1370 STEWART ST

PRIORITIES & BOARD RECOMMENDATIONS

After visiting the site, considering the analysis of the site and context provided by the proponents, and hearing public comment, the Design Review Board members provided the following siting and design guidance.

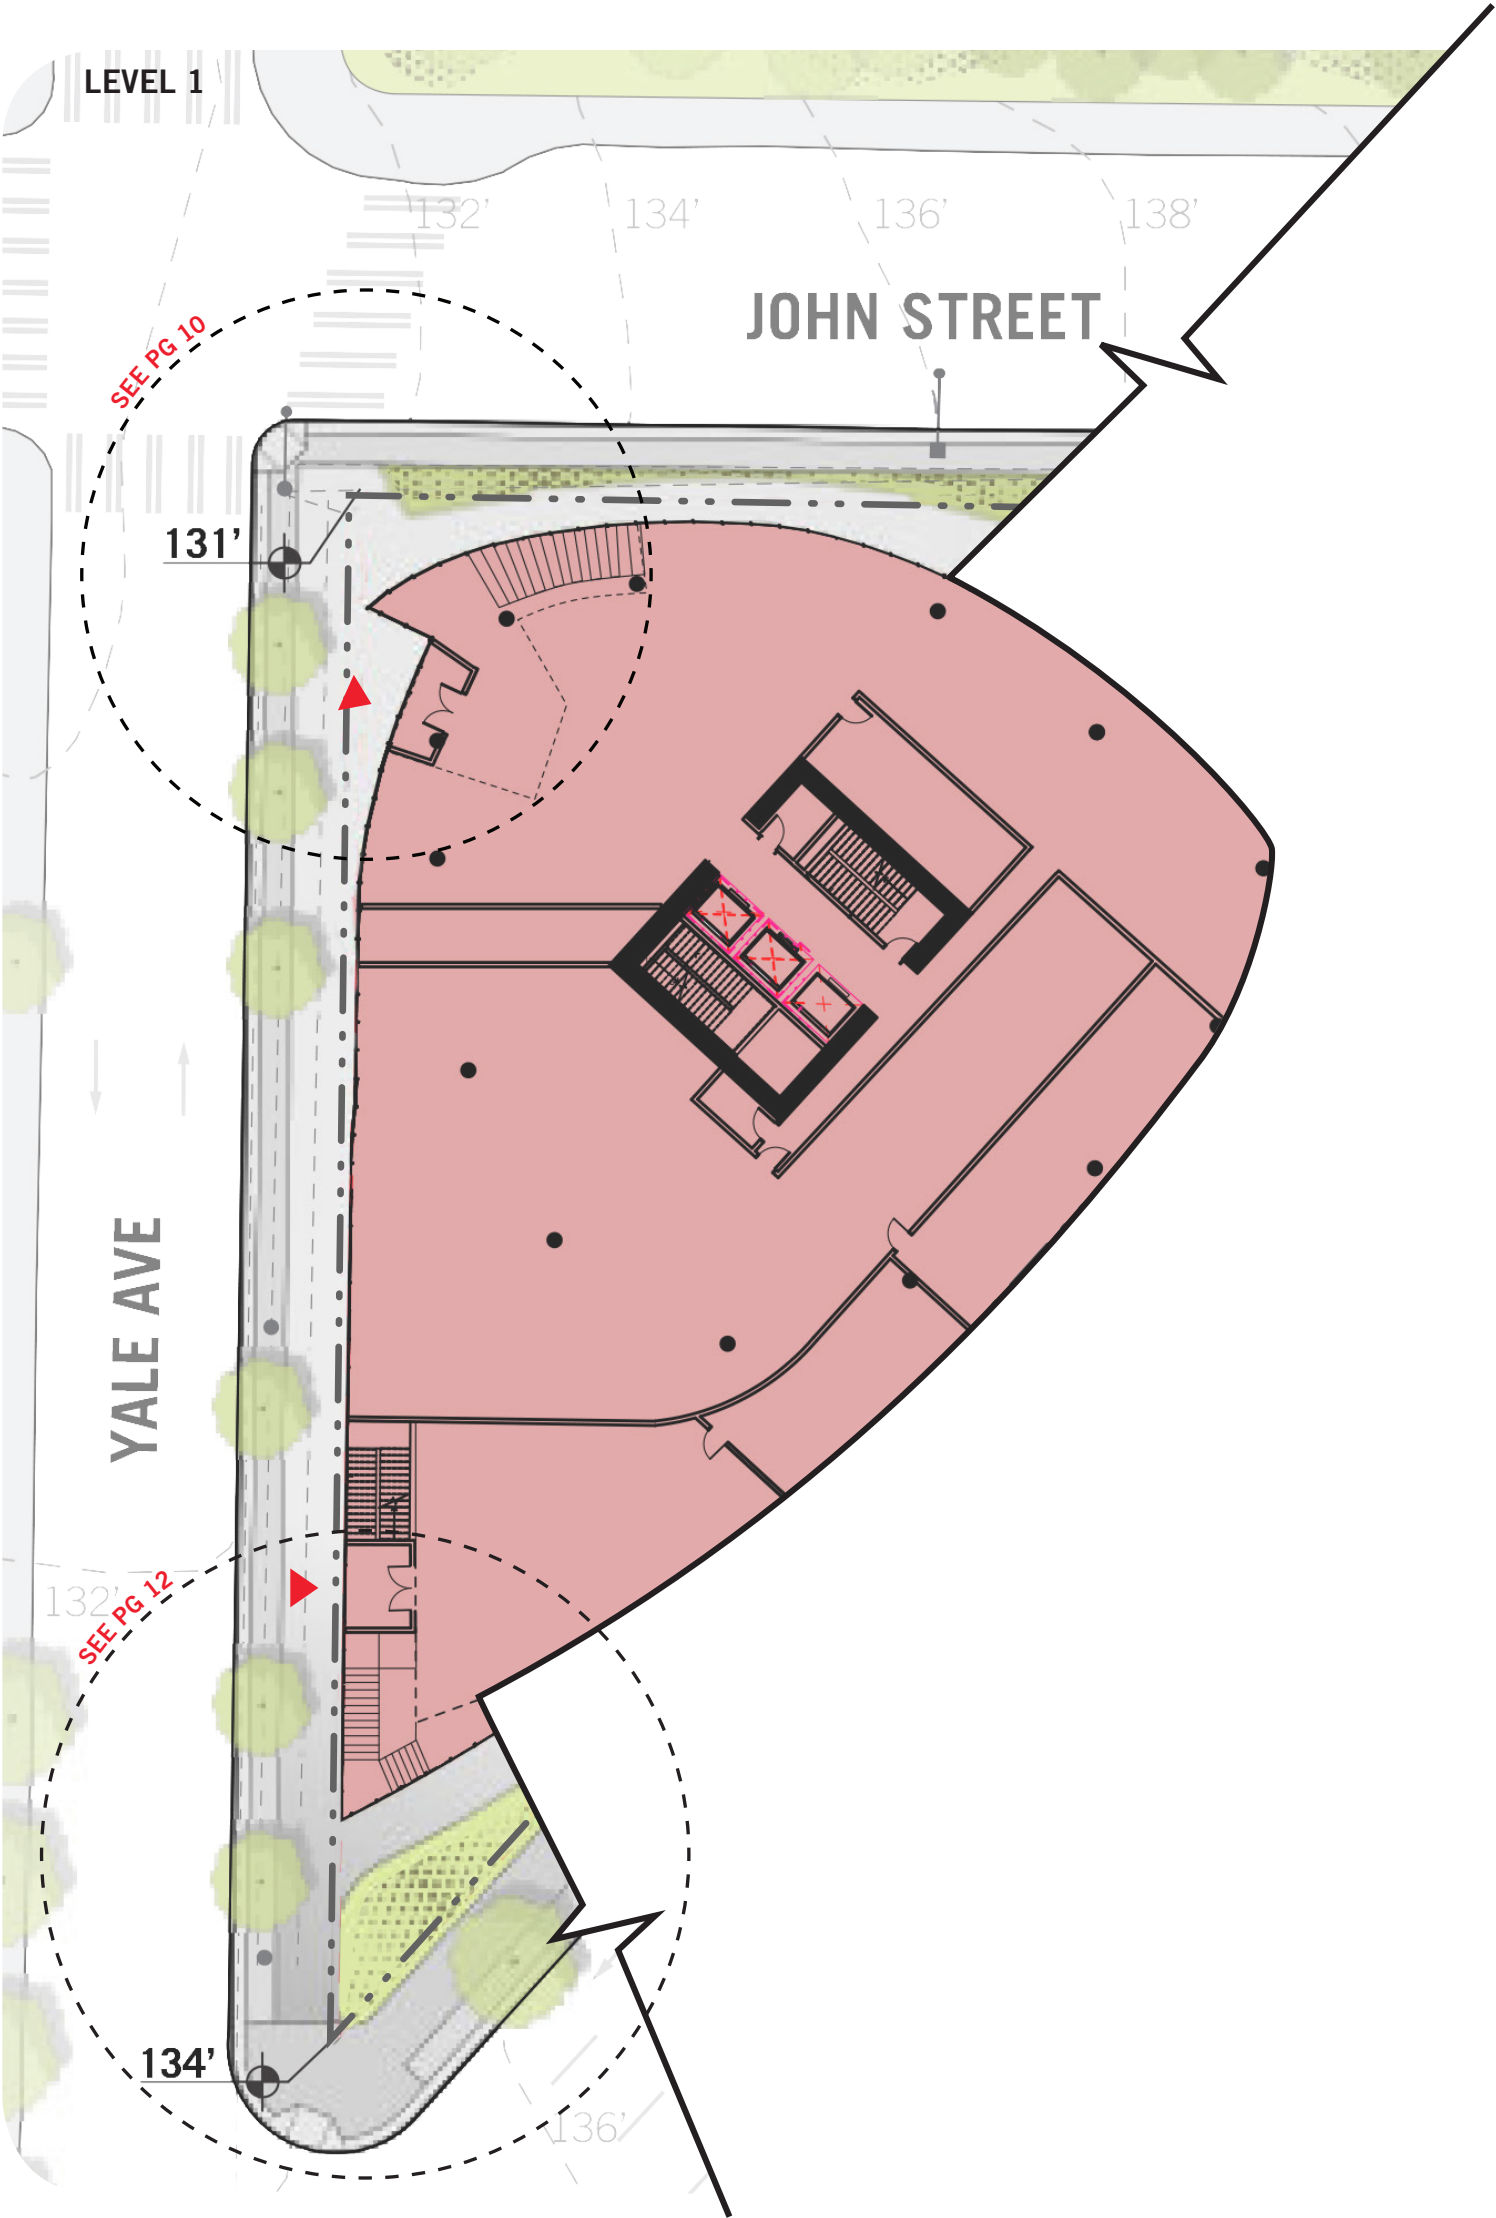
4A. The Board pointed out what appeared to be a concentration of ‘support’ areas at the north west corner and asked that these programming choices be revisited or explained in light of the corner’s importance in the pedestrian realm. (DC2-4-g)

5A. The Board supported the gesture at the northeast corner to the existing REI landscape but questioned apportioning the limited open space available to the least active corner. (DC3)

- i. The Board agreed that the current site plan could work but asked the applicant to explore the possibility moving that open space from the northeast to the northwest corner.

The Yale Ave frontage is proposed as an extension of the streetscape found to the north and adjacent to the Alley 24 development. This section of Yale is characterized by active frontages (lobby and retail), seating, curbside parking and passenger loading and street tree plantings.

Additional setbacks and curb bulbs at each corner of Yale have been included in the revised plans. The additional area creates opportunities for public amenities including seating, additional landscape and potential feature elements such as water or art. The setback also allows for spill out of retail seating at the active frontage.

Pocket seating areas and street tree are also included between the corners to extend the streetscape language.

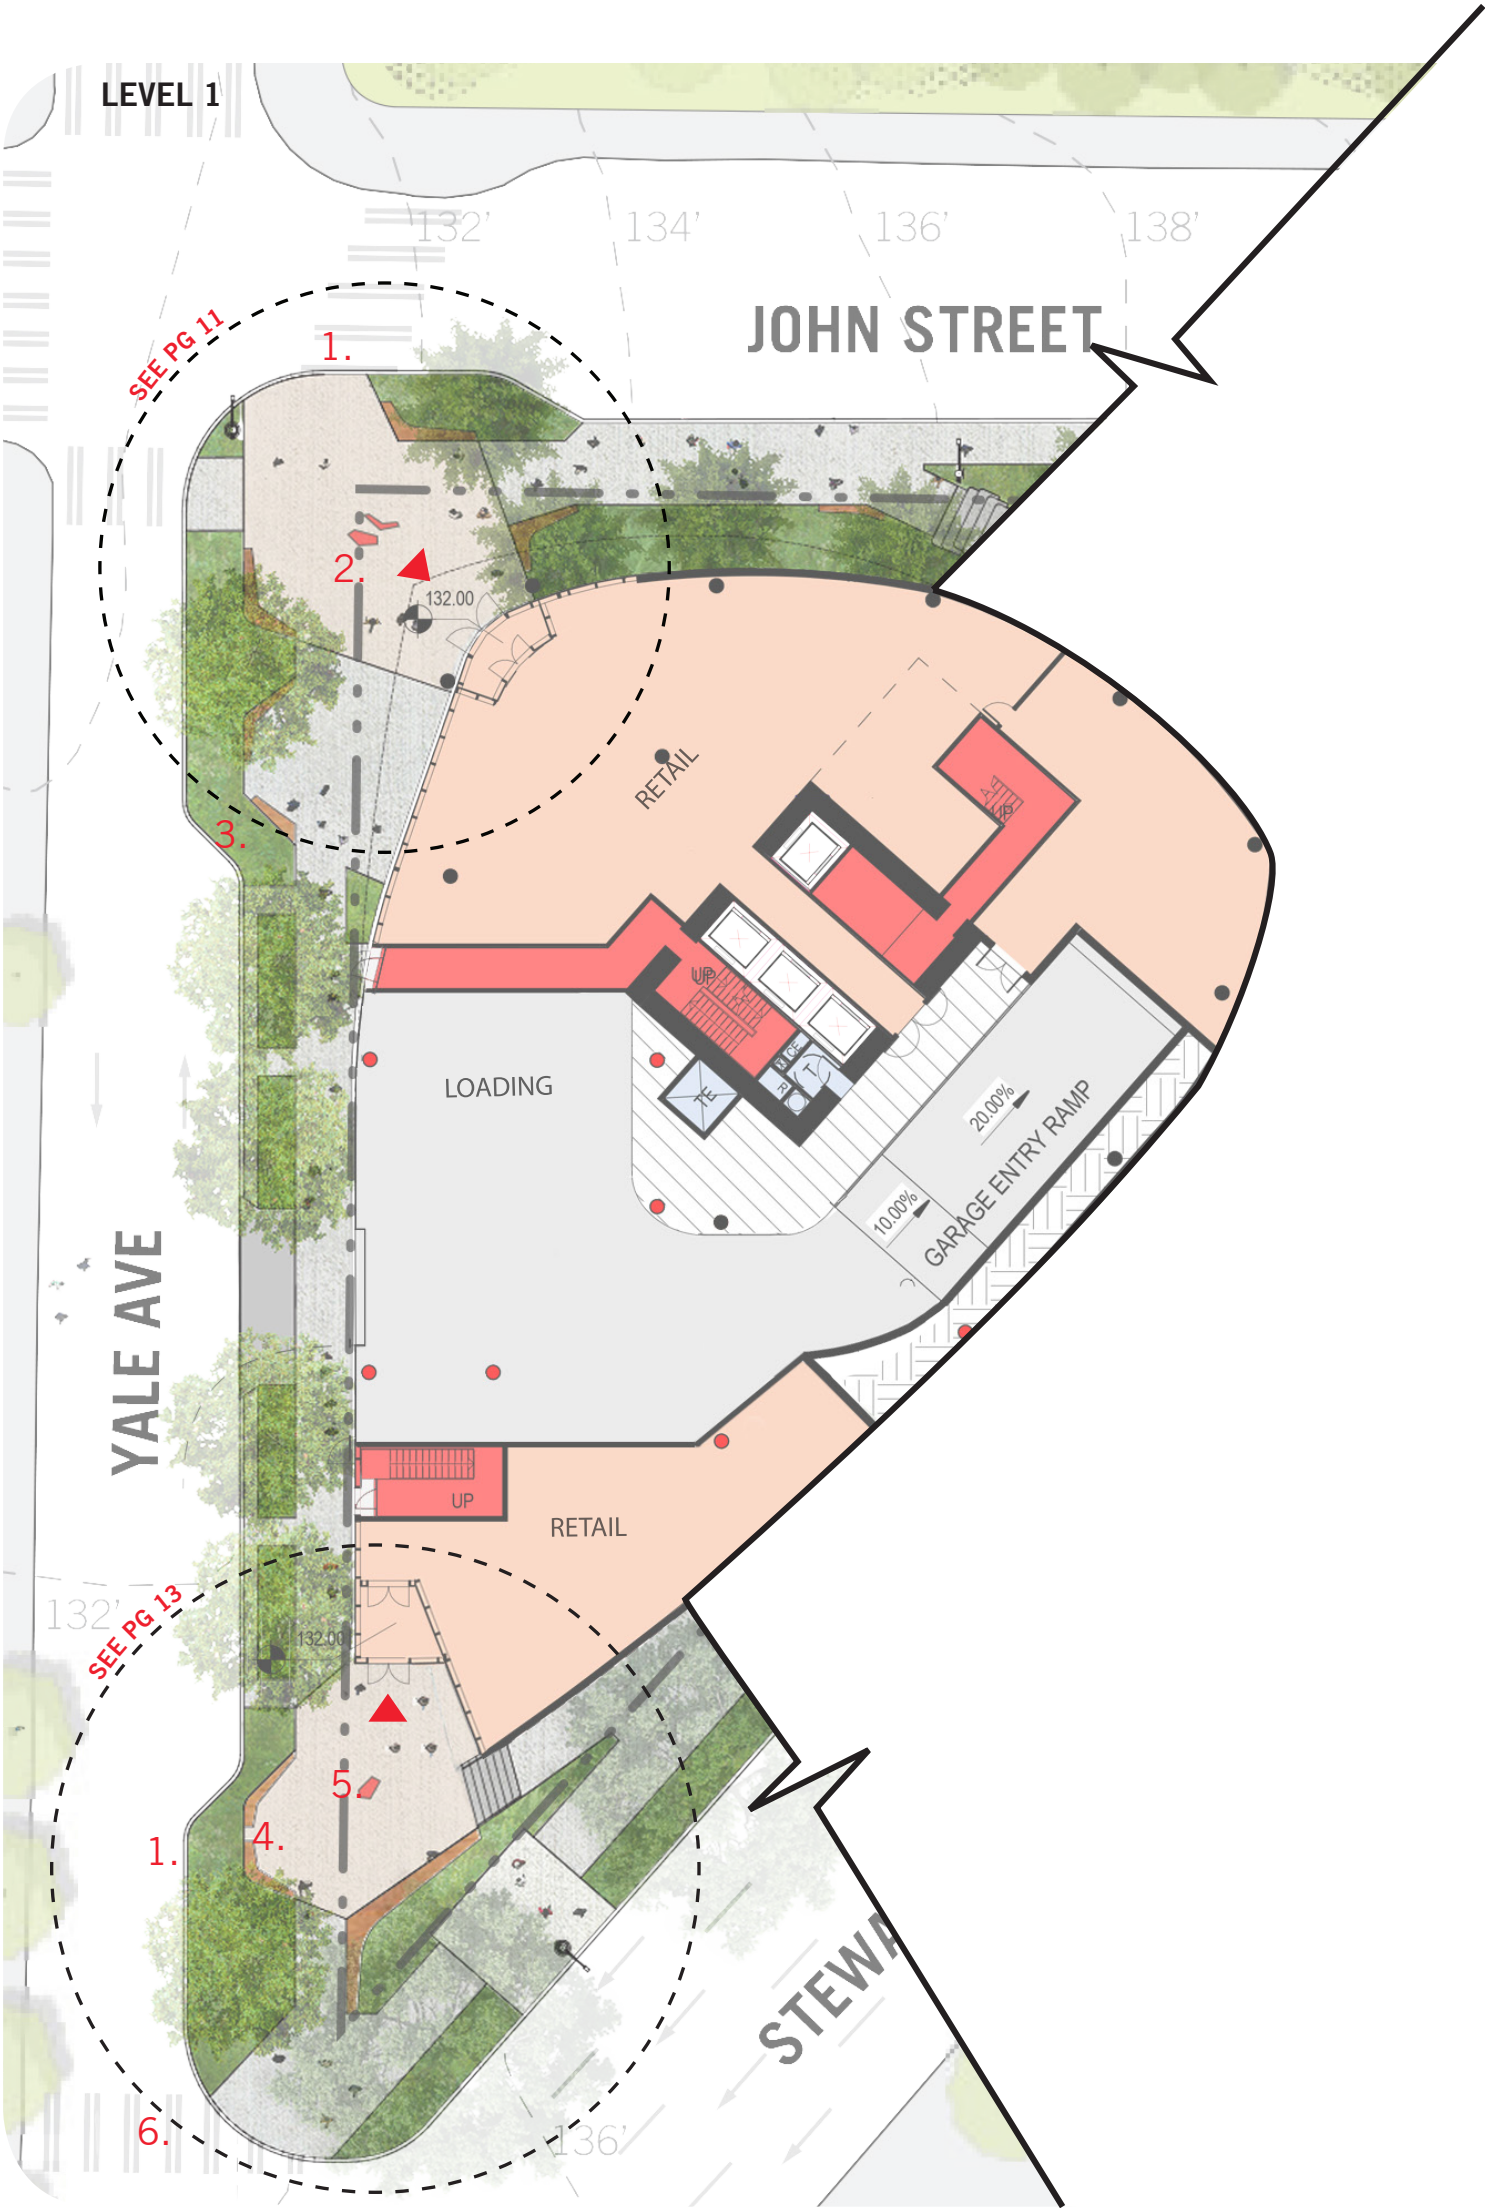
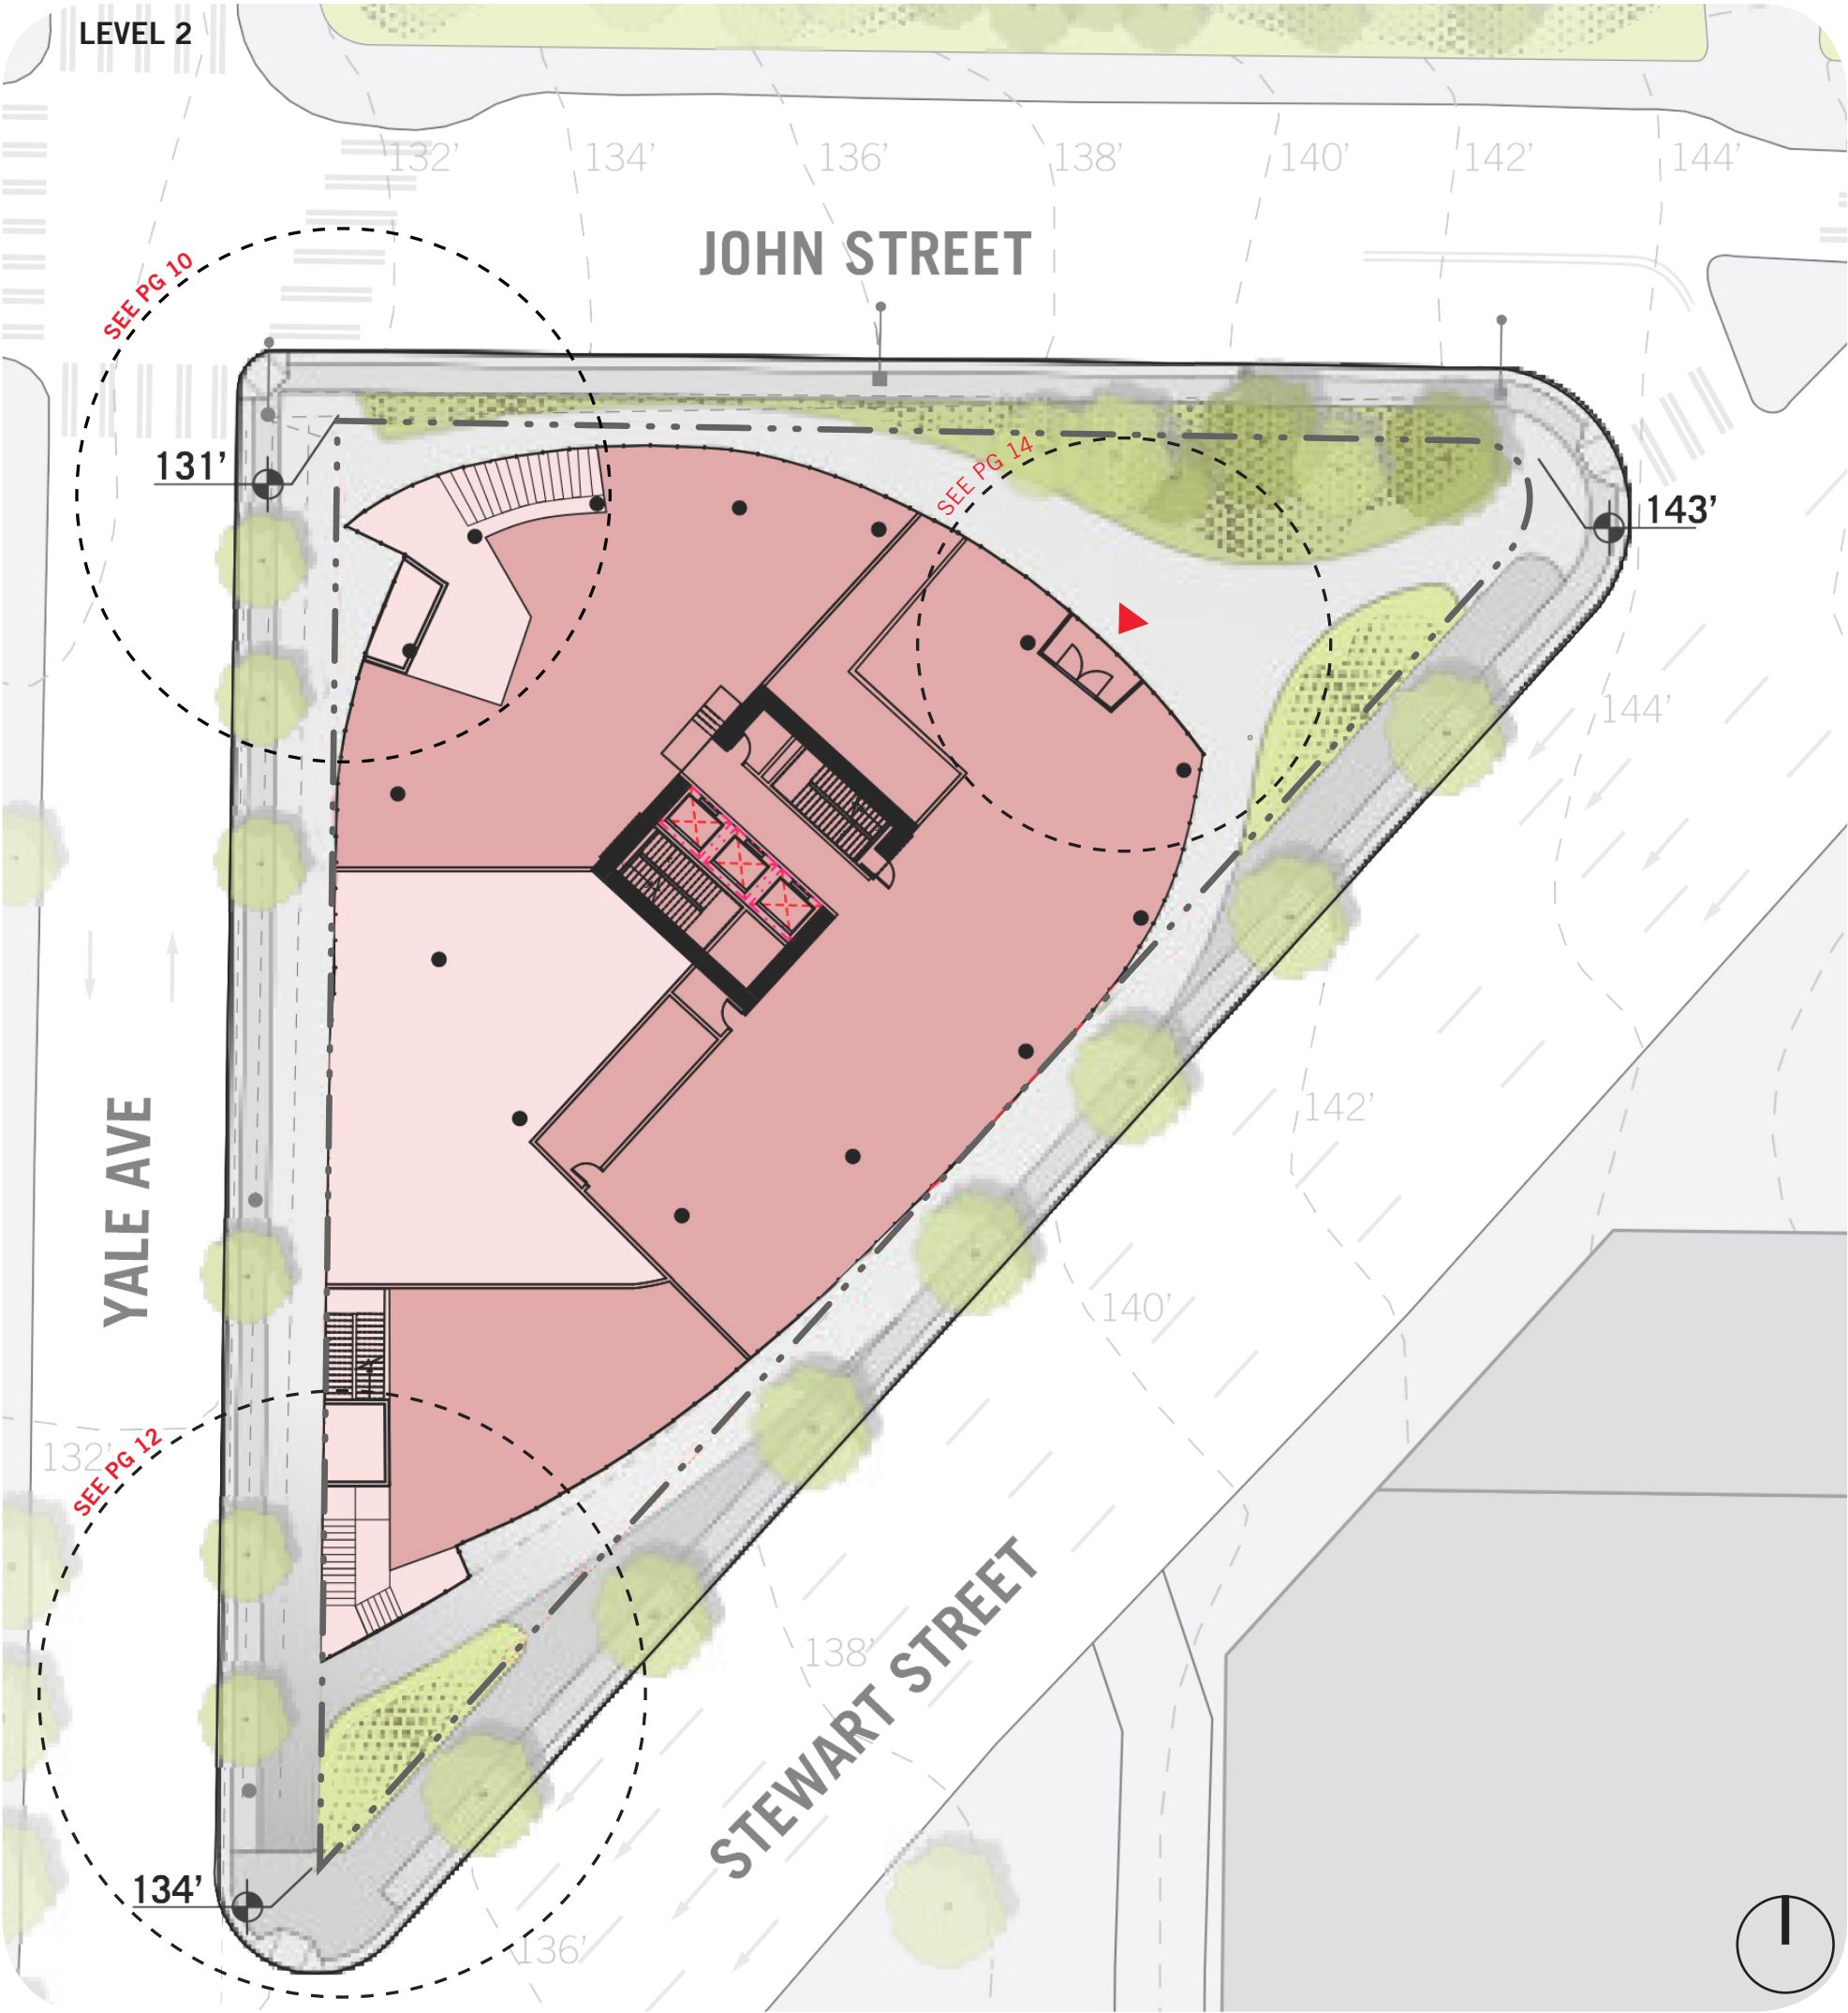
4A. The Board pointed out what appeared to be a concentration of ‘support’ areas at the north west corner and asked that these programming choices be revisited or explained in light of the corner’s importance in the pedestrian realm. (DC2-4-g)

5A. The Board supported the gesture at the northeast corner to the existing REI landscape but questioned apportioning the limited open space available to the least active corner. (DC3)

- i. The Board agreed that the current site plan could work but asked the applicant to explore the possibility moving that open space from the northeast to the northwest corner

The Yale Ave frontage is proposed as an extension of the streetscape found to the north and adjacent to the Alley 24 development. This section of Yale is characterized by active frontages (lobby and retail), seating, curbside parking and passenger loading and street tree plantings.

Additional setbacks and curb bulbs at each corner of Yale have been included in the revised plans. The additional area creates opportunities for public amenities including seating, additional landscape and potential feature elements such as water or art. The setback also allows for spill out of retail seating at the active frontage.

Pocket seating areas and street tree are also included between the corners to extend the streetscape language.
